AMENDMENTS TO THE DRAWINGS

REMARKS

Fig:2

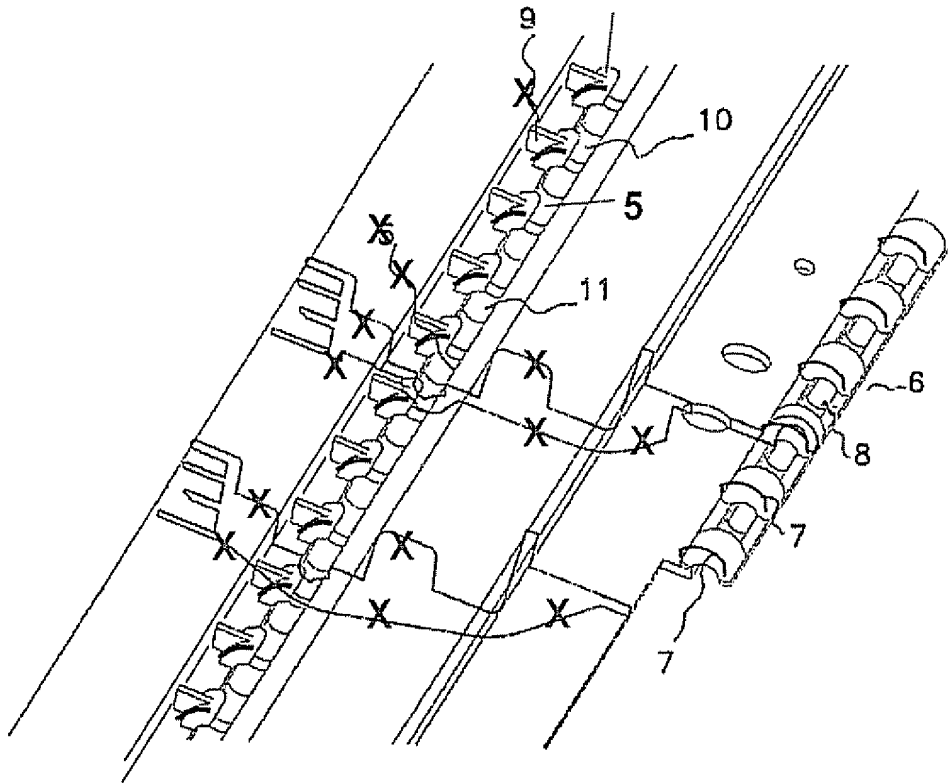
The attached sheets of drawings include changes to Figs. 2 and 4. These sheets, which include Figs. 1-4, replace the original sheets including Figs. 1-4. In Figs. 2 and 4, projection images have been deleted as shown in the attached annotated sheets, wherein deleted lines are marked with an "X." As only deletions have been made to the figures, no new matter has been added with the proposed amendments. Entry of the replacement sheets of drawings into the application is respectfully requested.

In paragraph 5 of the Action, the Examiner objects to the drawings under 37 CFR § 1.83(a). More specifically, the Examiner asserts that the elements of claims 2, 3, and 8 must be

shown in the drawings or the features canceled from the claims. Applicants hereby submit amended drawings, thereby addressing the Examiner's concerns. Accordingly, Applicants respectfully request reconsideration and withdrawal of the objection to the drawings.
